**SUPPLEMENT TO ALTERNATIVES SCREENING ANALYSIS
EVALUATION OF THE ASHLAND EAST VARIATION
PROPOSED BY THE SURFACE TRANSPORTATION BOARD**

**TONGUE RIVER RAILROAD
CUSTER, POWDER RIVER, AND ROSEBUD COUNTIES
MONTANA**

STB FINANCE DOCKET NO. 30186

August 23, 2013

Figure 2. Comparison of Vertical Profiles (Full size hard copy provided under separate cover)

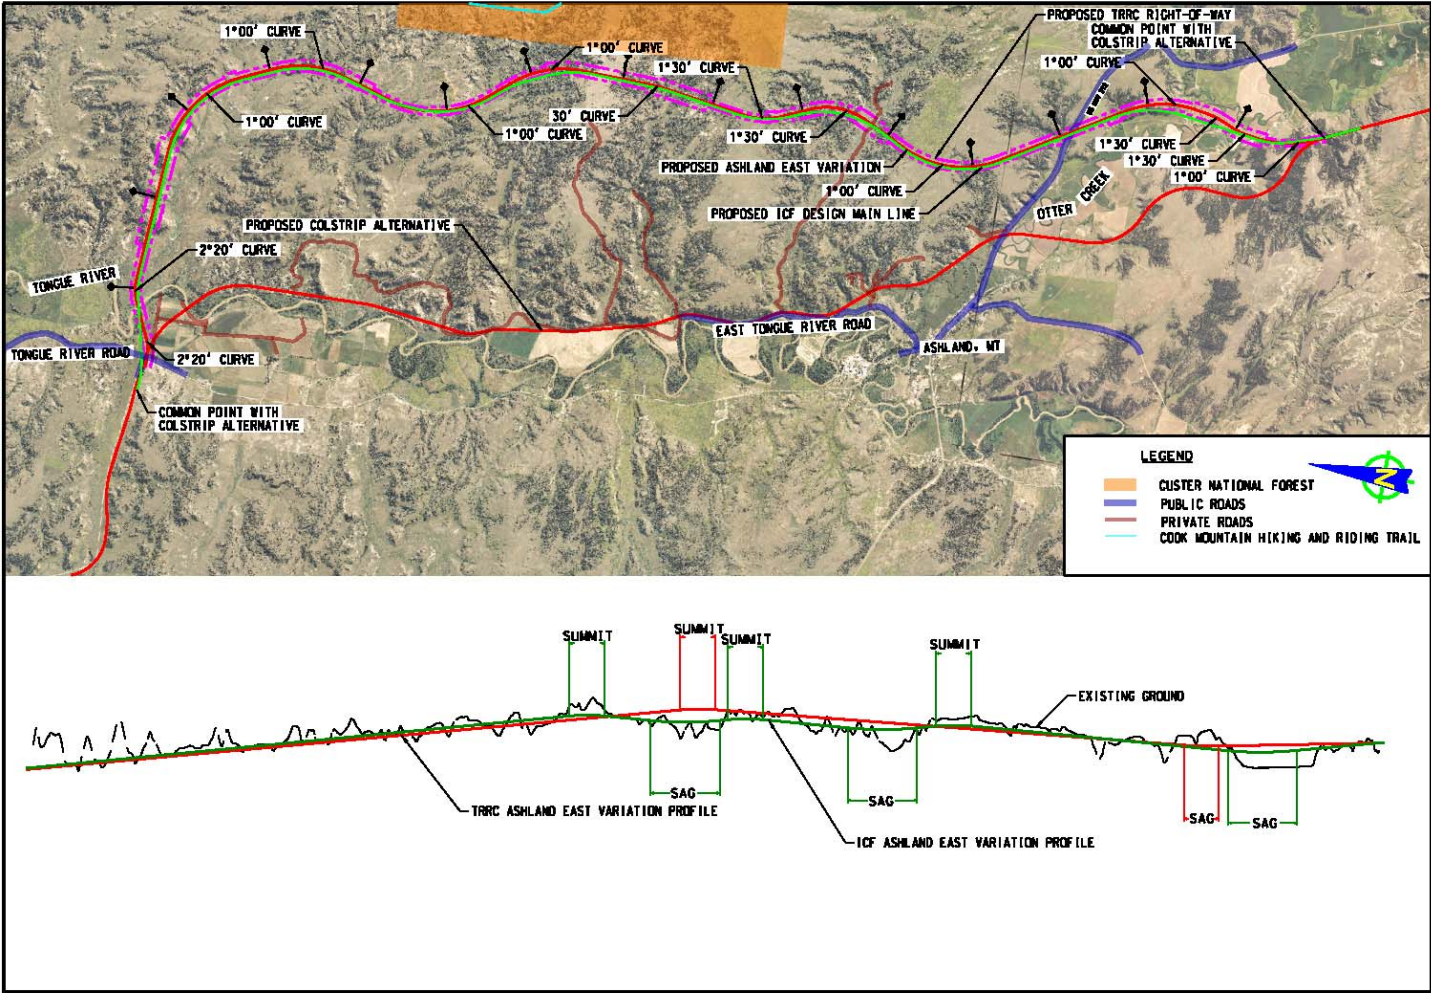
To ascertain the reason for this variation between the TRRC and OEA estimates, TRRC analyzed the horizontal and vertical design files provided by OEA for its Ashland East Variation estimates. It appears the primary reason for the differences in quantities is variation between the two vertical profiles used to estimate the quantities. After crossing the Tongue River heading east, both vertical alignments climb at maximum grade until a summit point, after which the OEA alignment more closely matches the existing ground topography through the use of six undulating maximum grades within a length of less than four miles. The TRRC vertical profile utilizes two maximum grades within the same length.

Figure 2 illustrates the existing ground topography and the TRRC and OEA vertical profiles. It appears that OEA has attempted to follow the existing ground topography in order to reduce the amounts of earthwork cuts and fills. However, TRRC and BNSF have serious concerns regarding future train operations over undulating tracks with such severe grade changes. Figure 3 illustrates the potential positions of two trains on the OEA version of the Ashland East alignment experiencing up to three maximum grades within an 8,000-foot train length (up, down, up). These multiple undulating grades within a train length can cause “bunching” and “stretching” of the trains, resulting in uneven speed control, increased wear on coupling devices, increased risk of coupling breaks at the top of the grades and increased risk of derailment at the bottom of the grades.

By contrast, the TRRC vertical profile of the Ashland East alignment is based on current railroad engineering practices and results in smooth pulls both up and down grades. The OEA Ashland East Variation profile utilizes undulations with a total grade approximately 25% greater than the other alternatives. However, unlike other alternatives, which employ isolated undulations of lesser severity, the OEA Ashland East profile proposes six consecutive undulating maximum grades, each connected by less than a train length. This segment of the OEA profile is inconsistent with best practices for railroad engineering and safety and accordingly would not be constructed according to the design parameters used by OEA due to the increased derailment and coupling risks. In comparison, the portion of the preferred Colstrip Alignment west of Tongue River utilizes no similar undulations containing three grades within a train length.

As a result of the above analysis, TRRC believes that it would be inappropriate to rely on the OEA earthwork estimates for alignment comparison purposes. The TRRC estimates initially presented in the April 30 Supplement and shown above in Table 1 better reflect the actual impact of constructing the Ashland East alignment according to best engineering practices that would be employed by TRRC as the party constructing the line.
